TENDER ADDENDUM

Project:	UHN Interventional Fluoroscopy Replacement University Hospital of Northern British Columbia 1475 Edmonton Street, Prince George, BC V2M 1S2	Tender Addendum #:	02
		DCTYA Project #:	2009
		NHA Project #:	N662050005
		Issued By:	Douglas Cheung
To:	All Bidders	Issue Date:	Feb 26, 2021
Copies To:	Leah Joseph / Northern Health Authority

STRUCTURAL ADDENDUM No. 2

Project: UHN Fluoroscopy Replacement **File:** 11815
Architect: DCYT Architecture, Douglas Cheung **Date:** February 26, 2021

ARCHITECT :

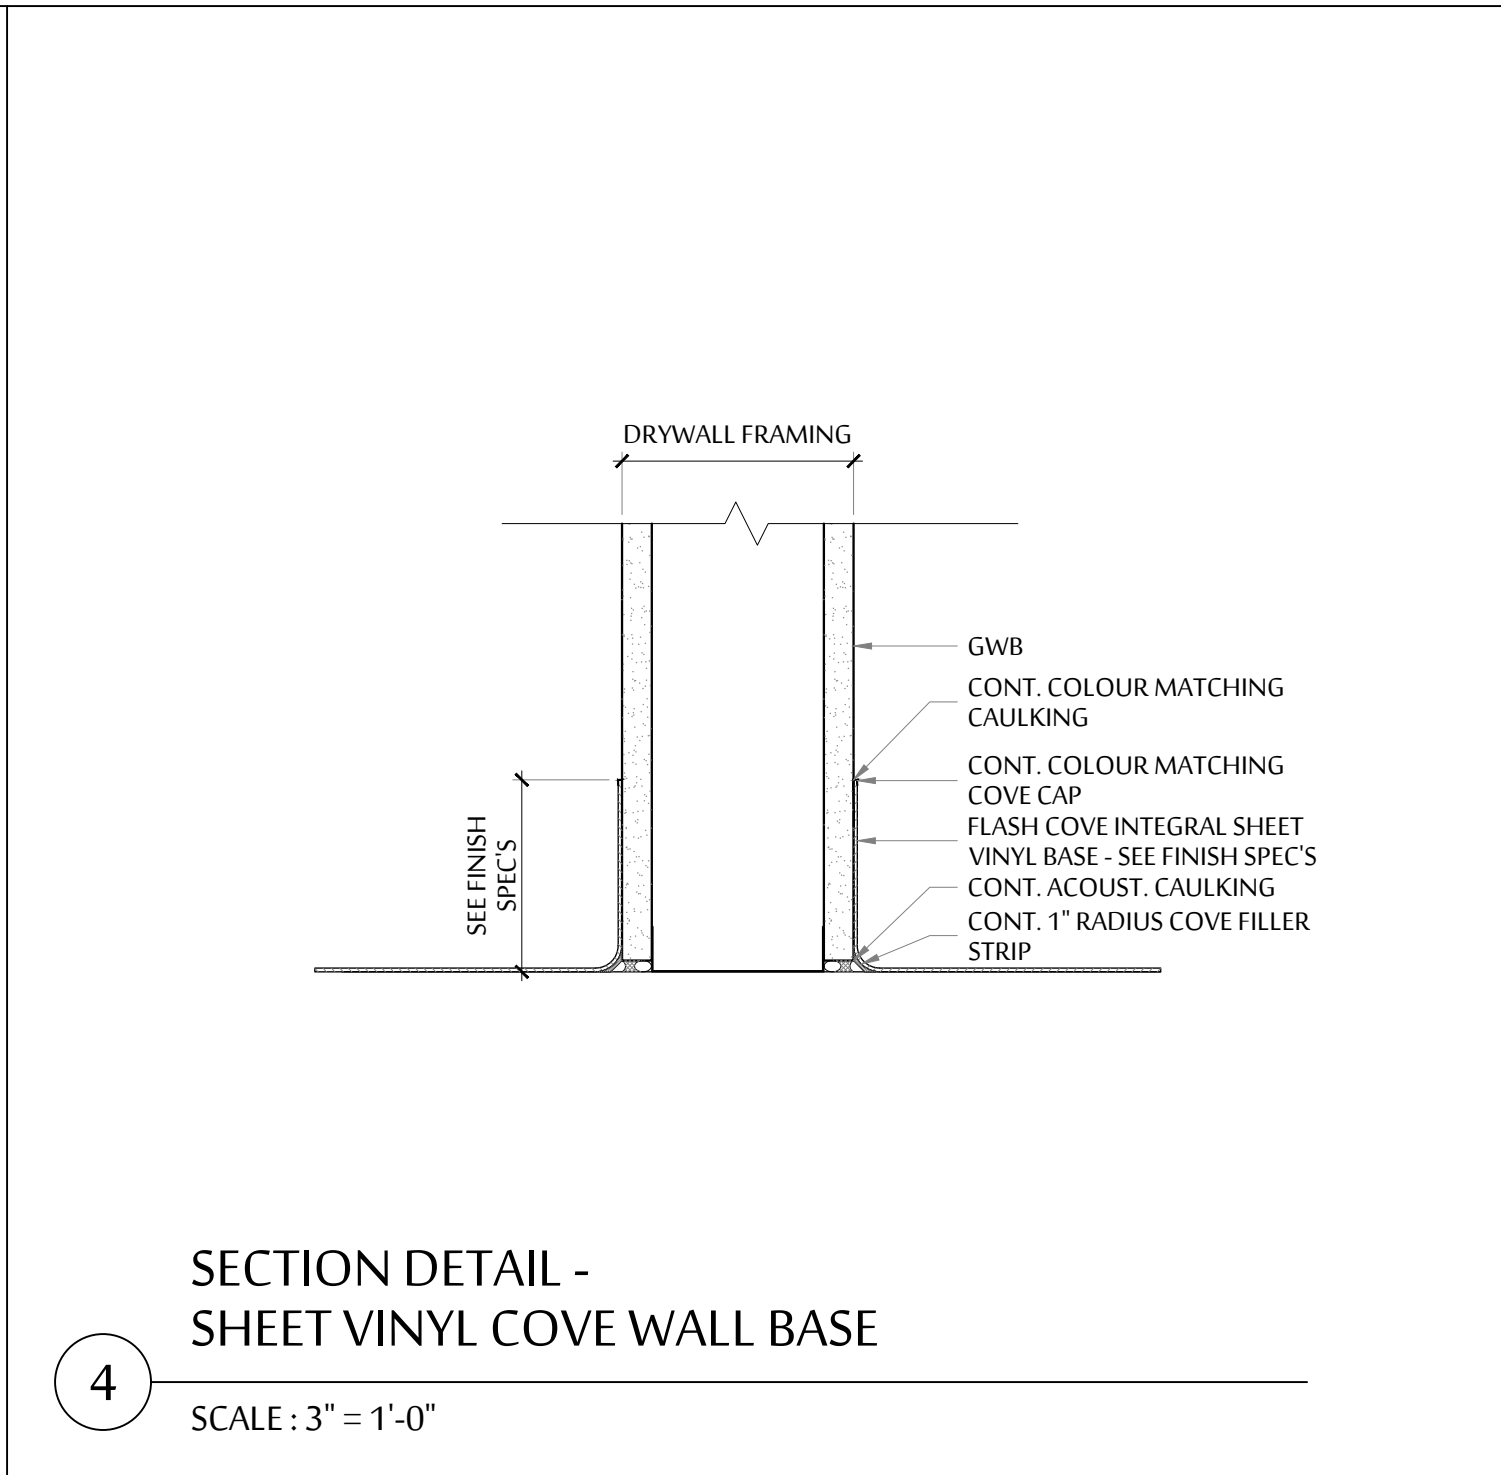
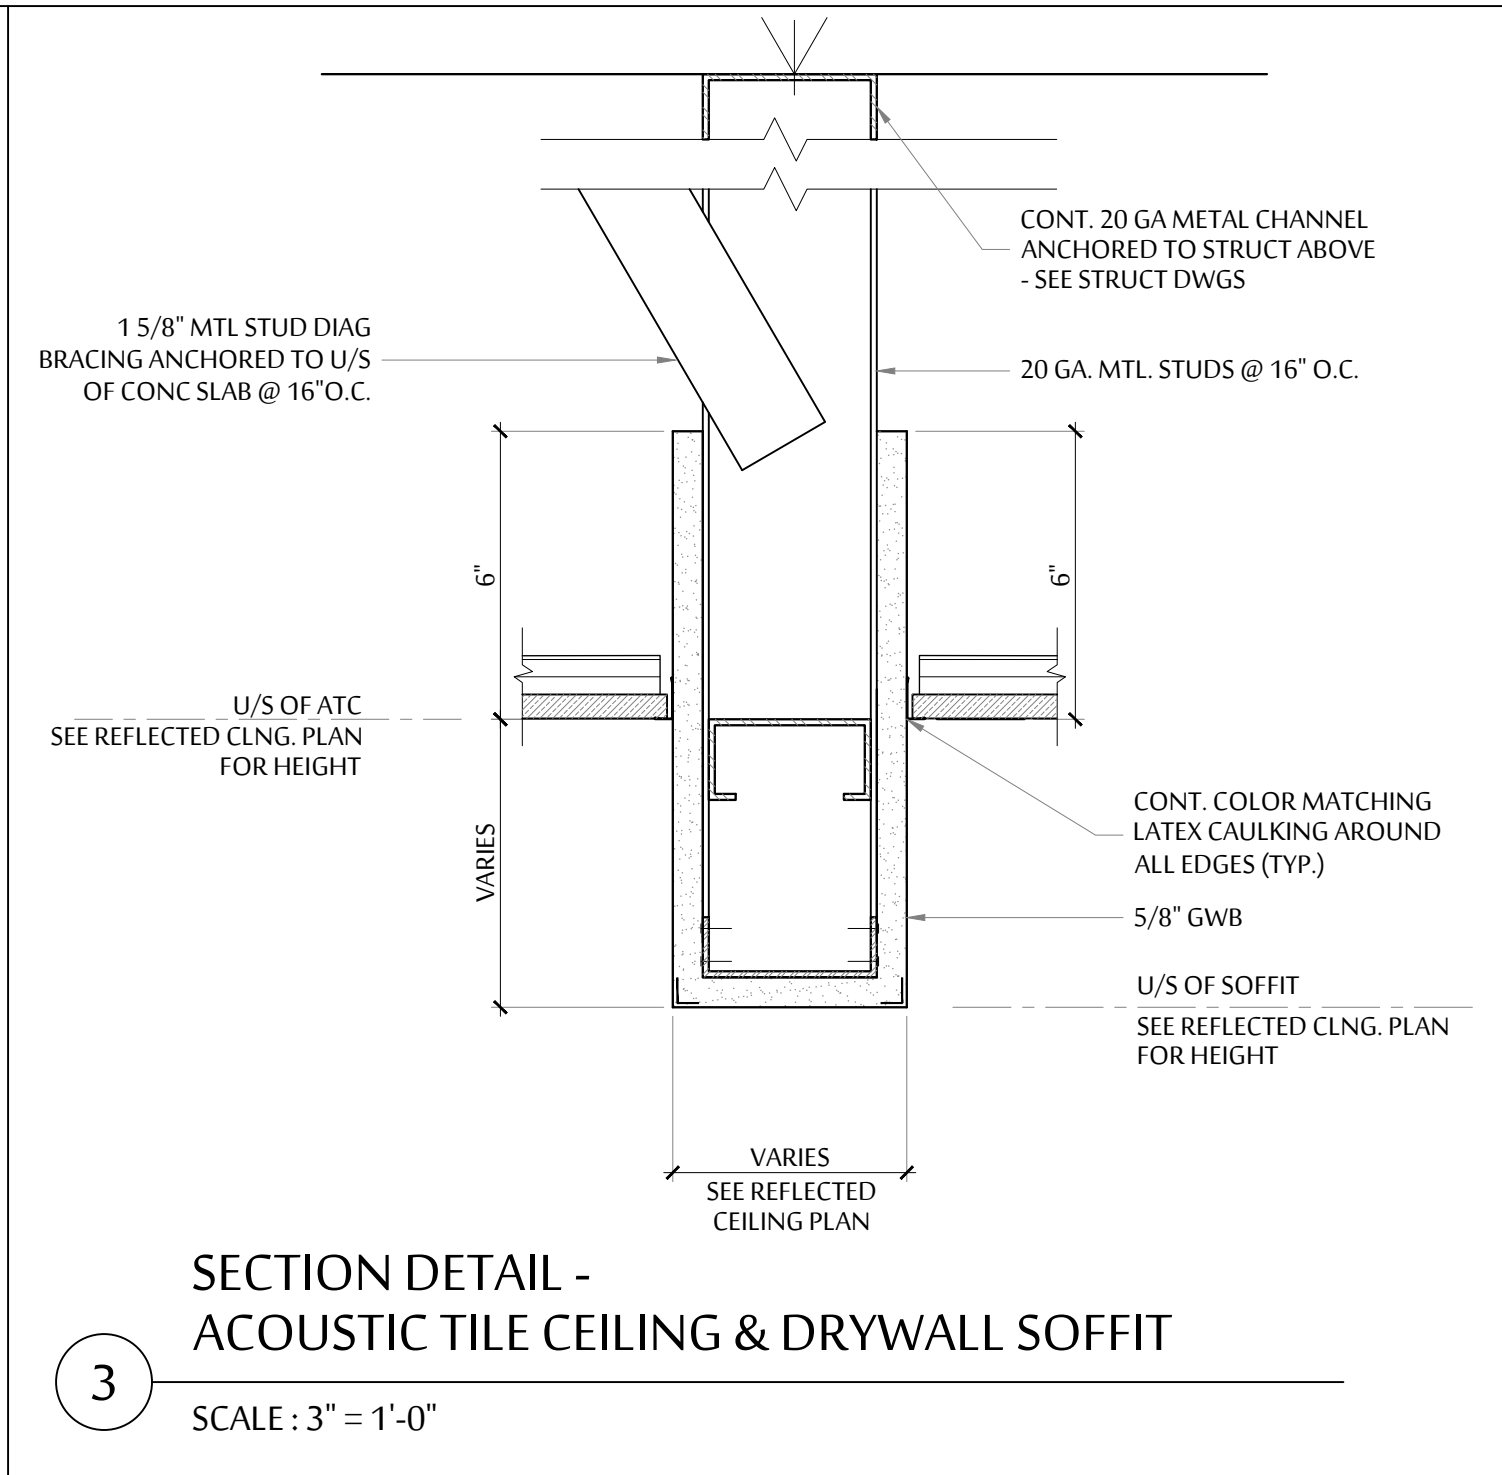
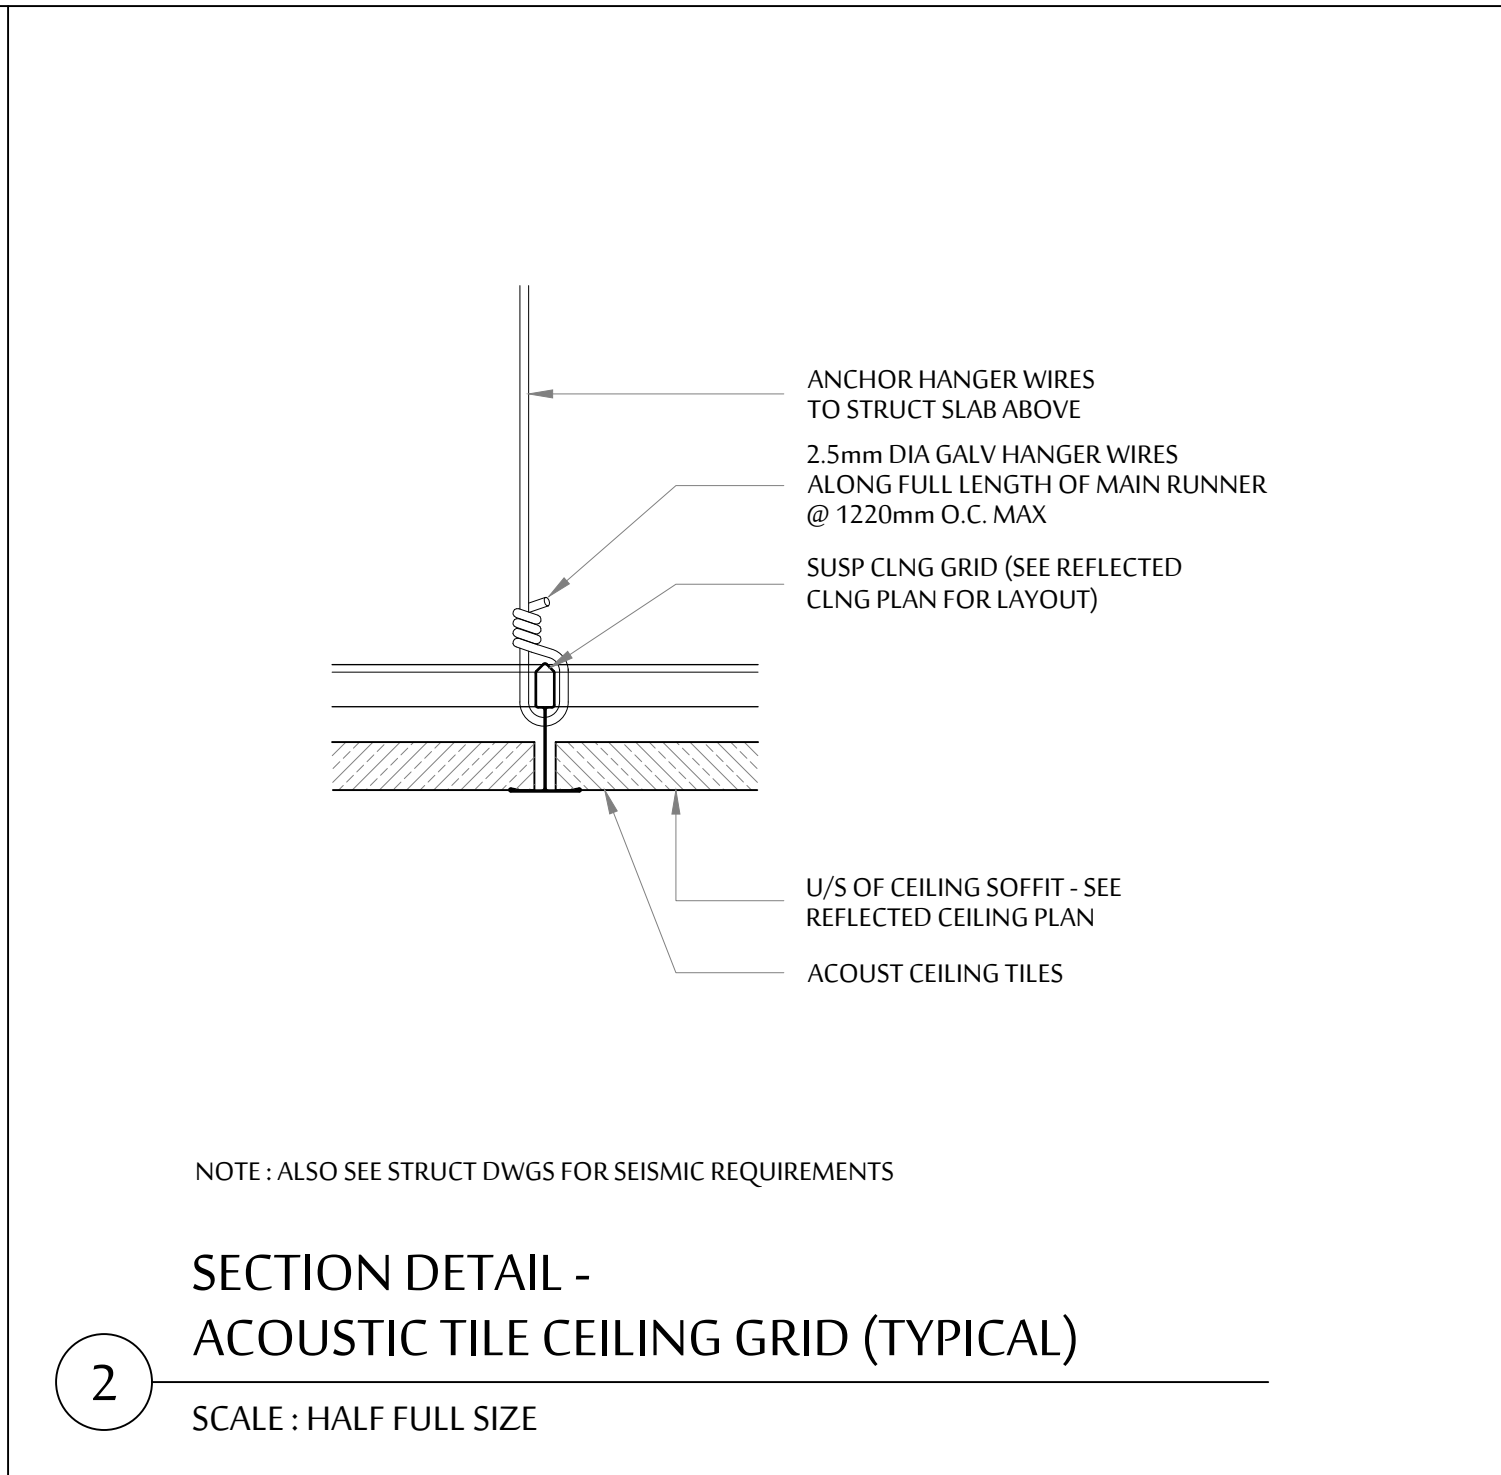
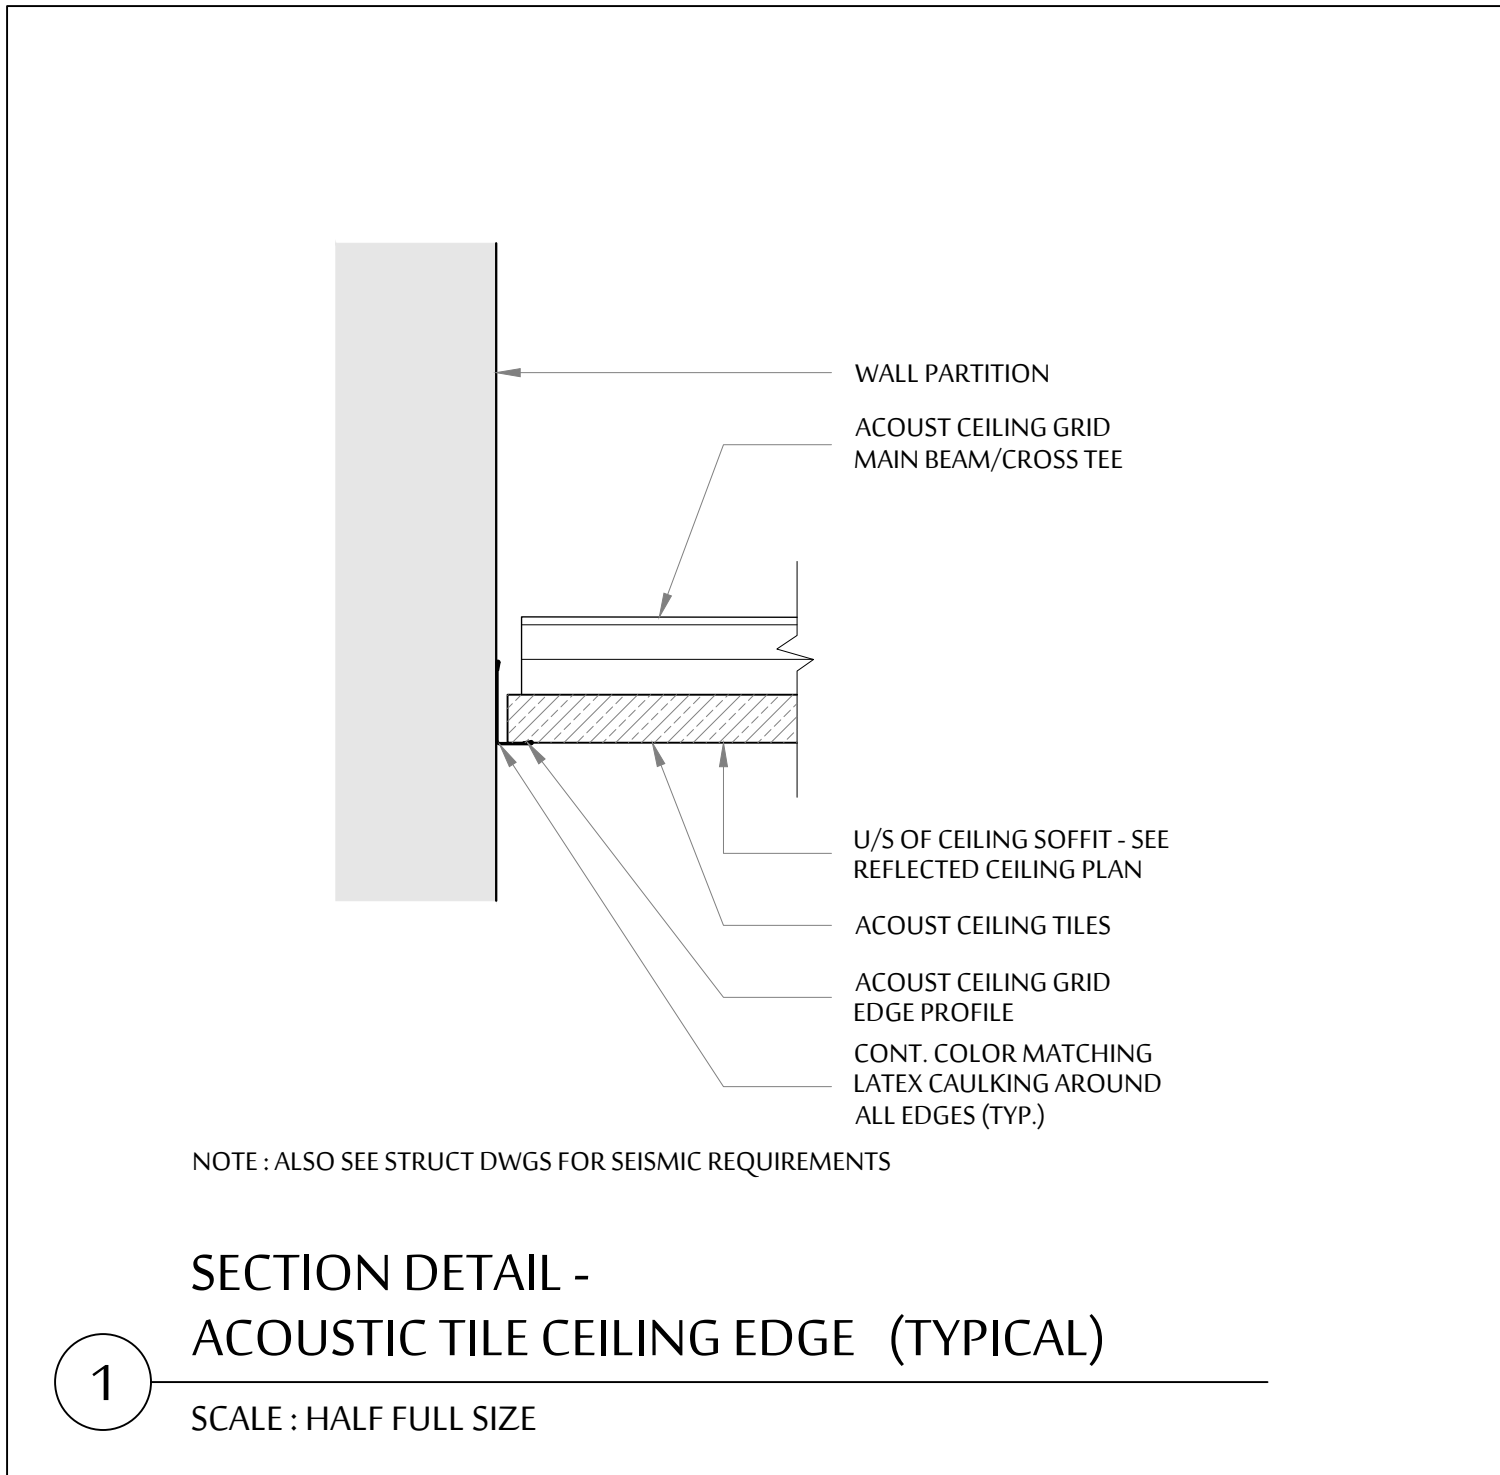
- 5.1. See attached Dwg A2.06 – Roof Plan, for revisions to roof plan and roof construction key notes.
- 5.2. See attached Dwg A5.03 – Typical Details, for detail revisions.
- 5.3. See attached ADD2-A02 – Part of Dwg A5.02, for revisions to finishes and fixtures schedule.
